DATE: June 15, 2022
 AGENDA ITEM #4

TO: Design Review Commission
FROM: Nazaneen Healy, Associate Planner
SUBJECT: SC22-0002 – 632 Leaf Court

This is a design review application for a new 3,878 square-foot two-story single-family residence. The project includes 3,171 square feet on the first story and 707 square feet on the second story. This project is recommended to be considered categorically exempt from further environmental review under Section 15303 of the California Environmental Quality Act since it involves the construction of one single-family residence in an area zoned for residential uses. The following table summarizes the project’s technical details:

FRONT ELEVATION - (NORTH)

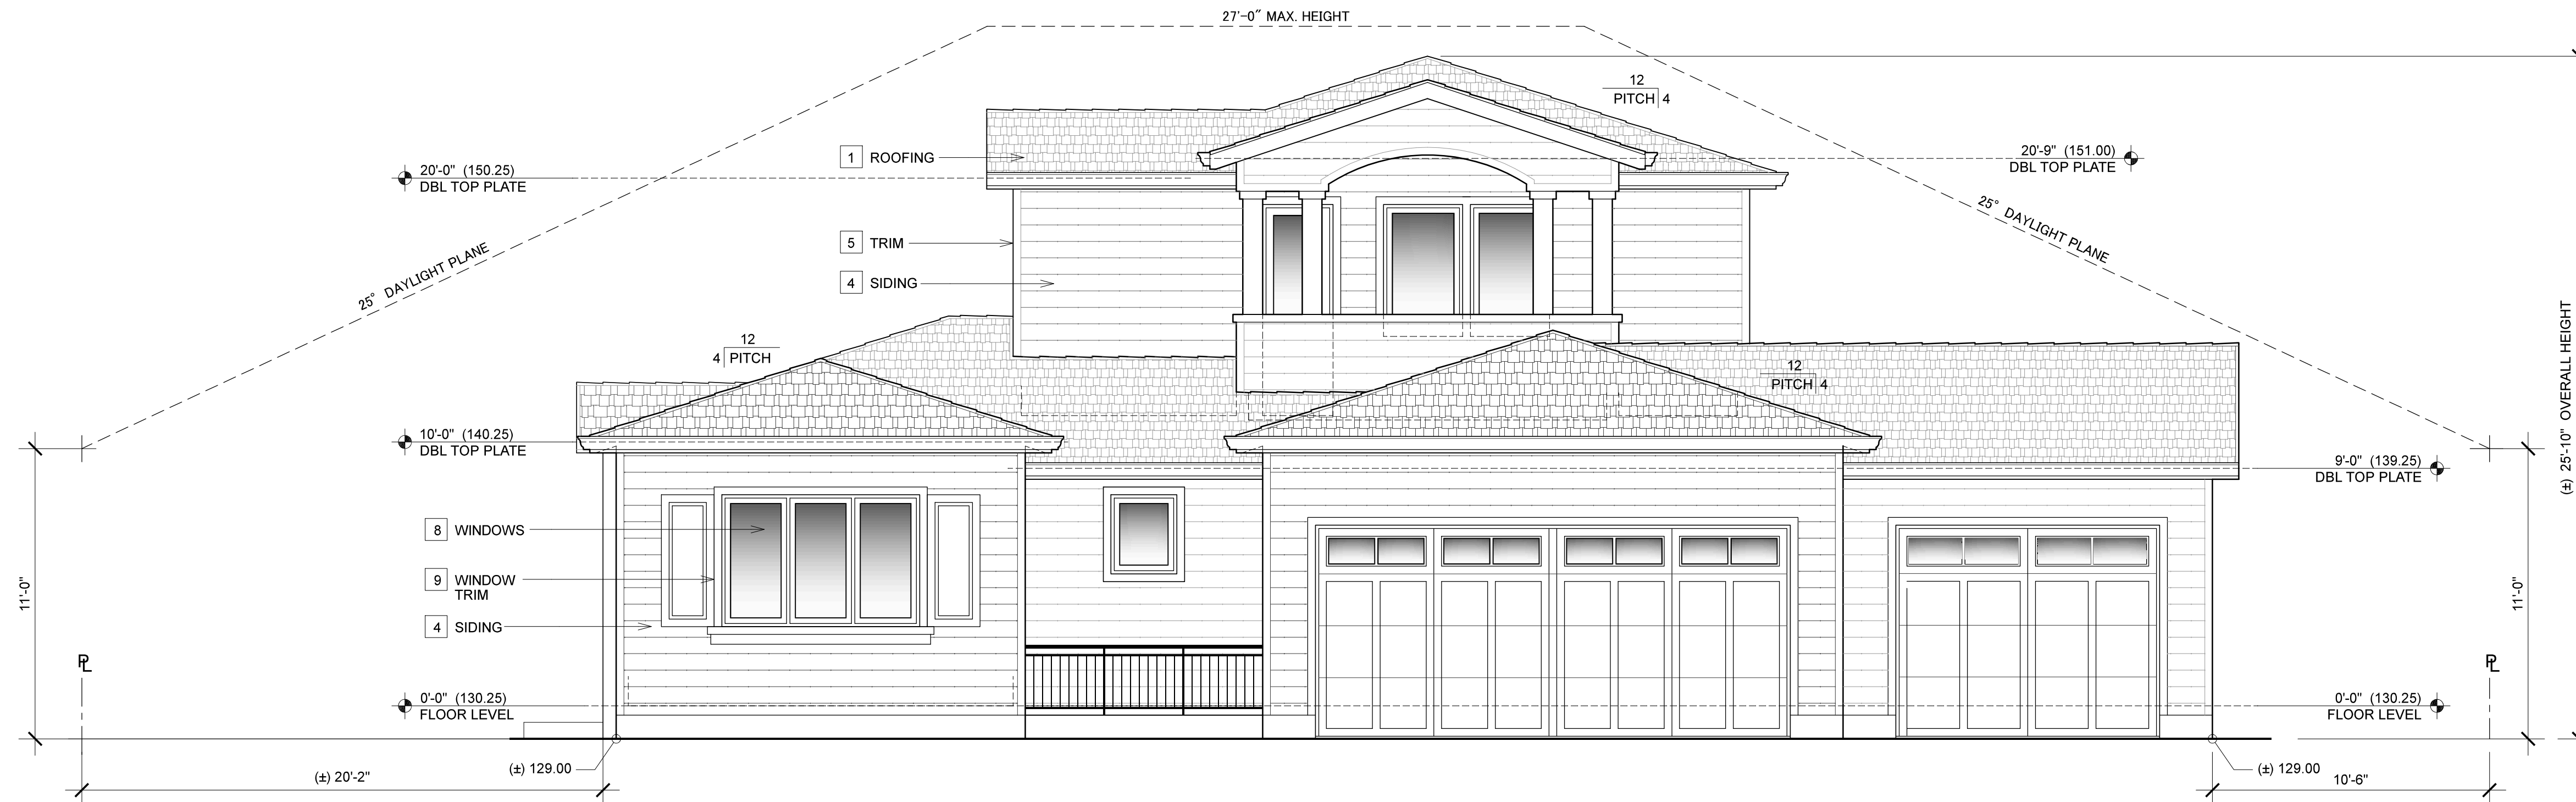
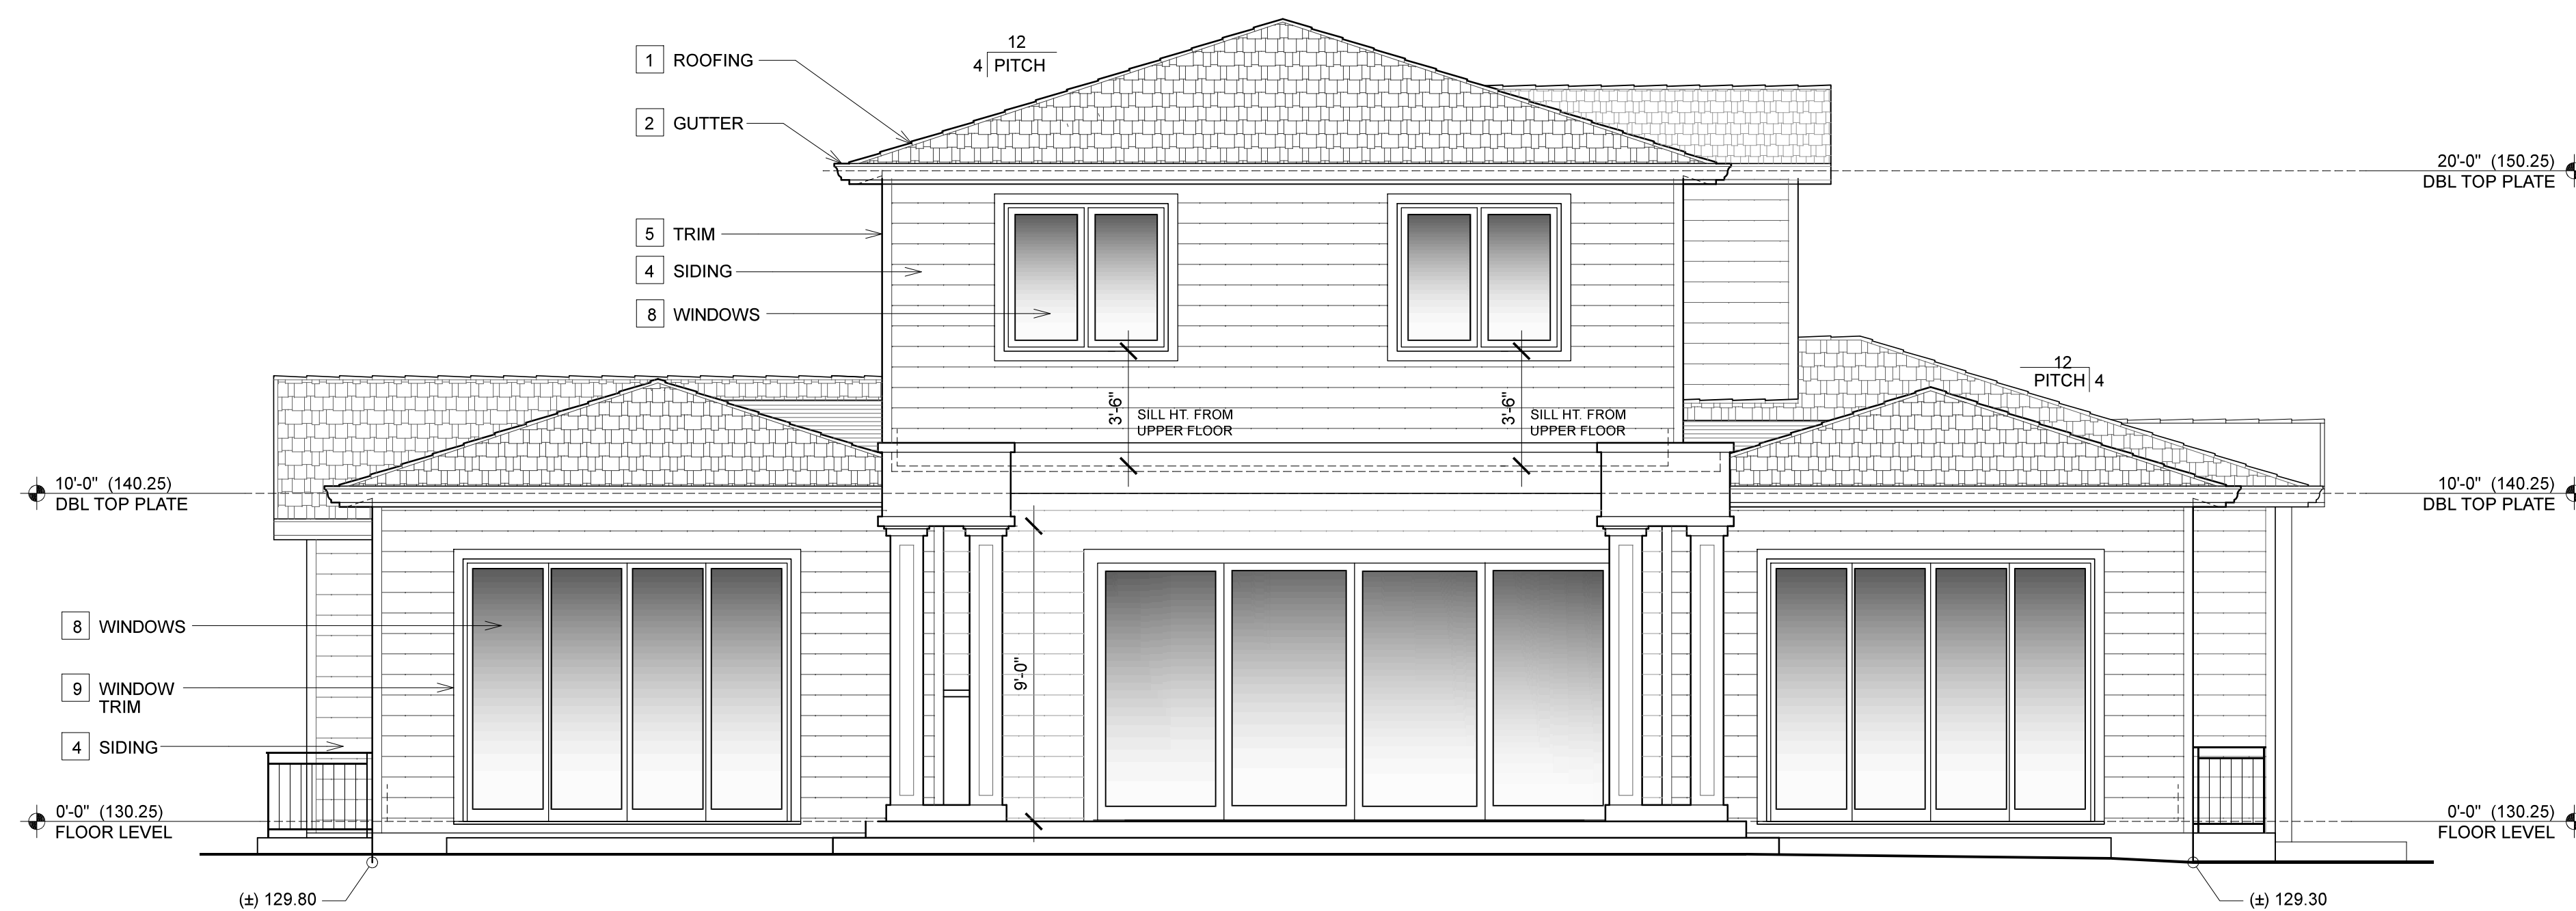
Similar to the existing two-story homes nearby, the proposed design includes a relatively small second-story footprint (707 square feet) compared to the first floor (3,171 square feet). The second floor is also set back considerably from the first floor on all sides which helps minimize the appearance of bulk consistent with the Design Guidelines. That said, the proposed first floor plate heights and second floor plate heights range from 9'-0" to 10'-0" and 9'-0" to 9'-9" respectively. The DRC may want to discuss whether reducing the height of the proposed plate heights would improve compatibility with the surrounding neighborhood.

Section 5.6 of the Design Guidelines calls for avoiding designs that make the garage a focal point and provides several methods for reducing the prominence of a garage, some of which have been

incorporated into the proposed design including offsetting the building walls to break up the façade of the three-car garage and using hipped roof forms. If the DRC is concerned with the visual impact of the garage, the DRC may want to discuss additional methods that may improve the design such as setting back the front of the garage from the front of the home and/or lowering the plate height.

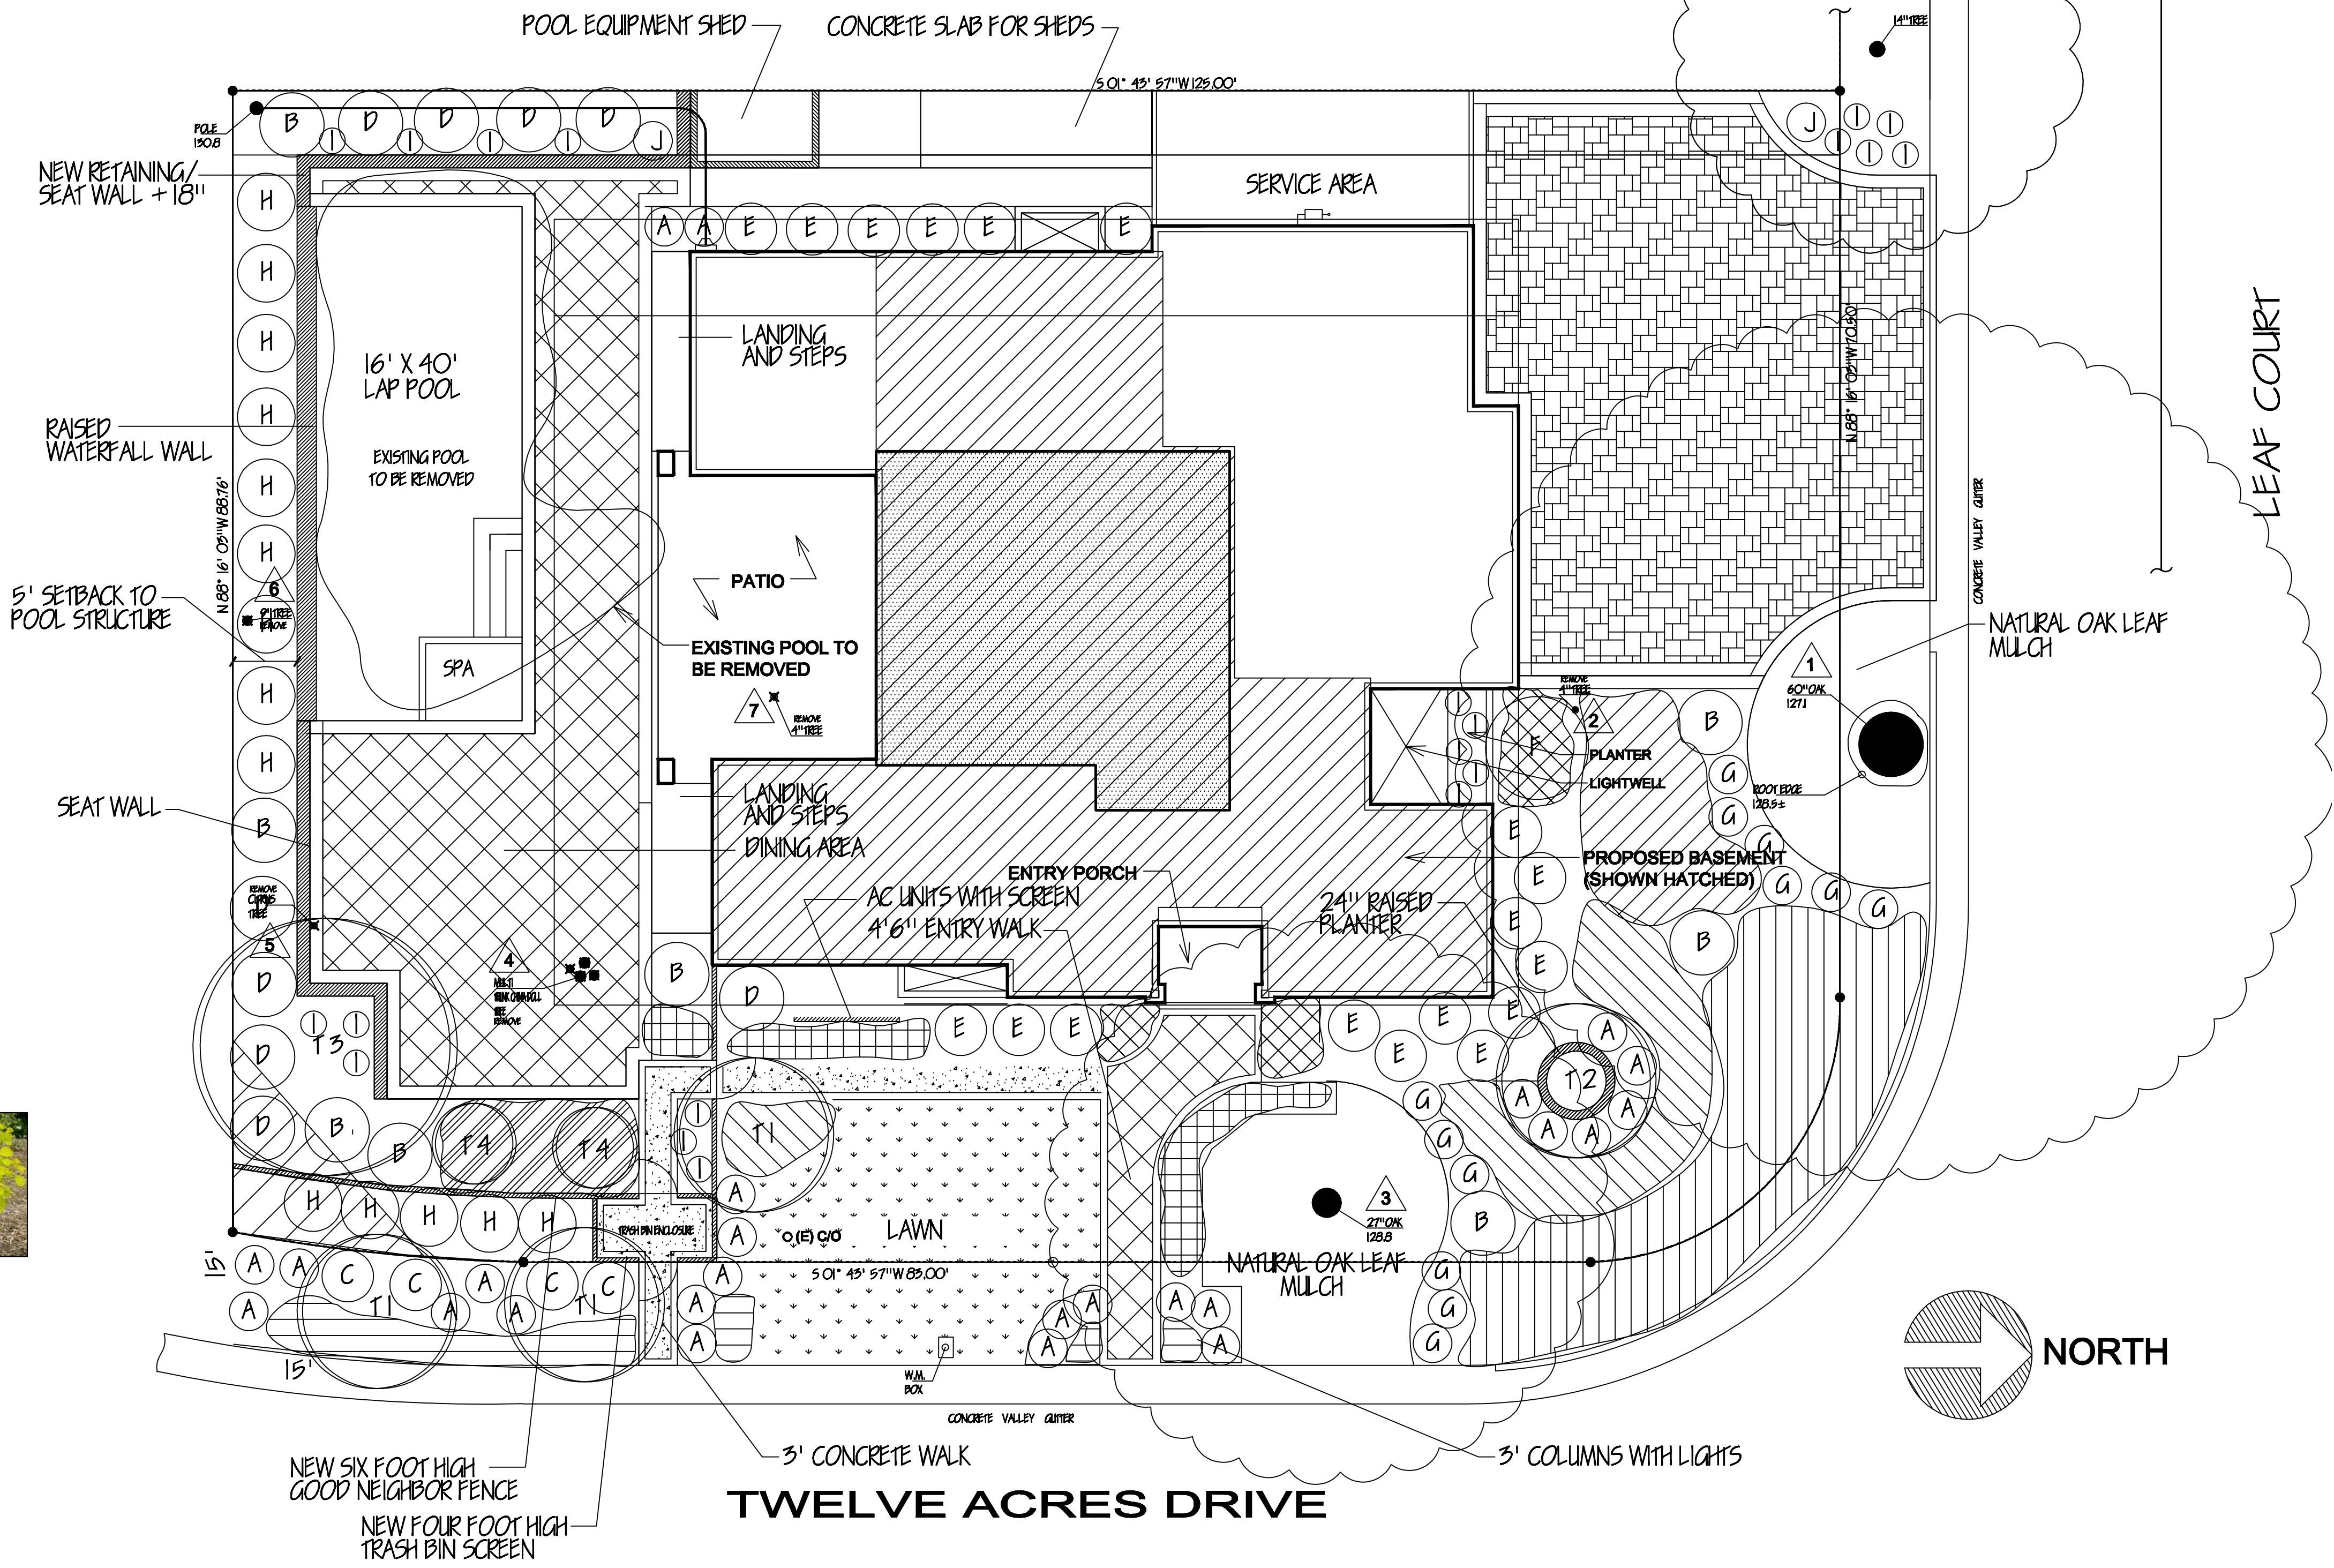
The landscaping plan proposes new screening plants along the rear of the property, in addition to trees, shrubs, and groundcovers throughout and a turf area in the exterior side yard. The new landscaping will need to satisfy the Water Efficient Landscape Ordinance requirements since it exceeds the 500 square-foot landscaping threshold for new residences (Conditions of Approval No. 12 and 16).

- b. On the Landscape Plans extend the proposed rear yard screen tree plantings along the rear property line to the planting area along the interior side property line.
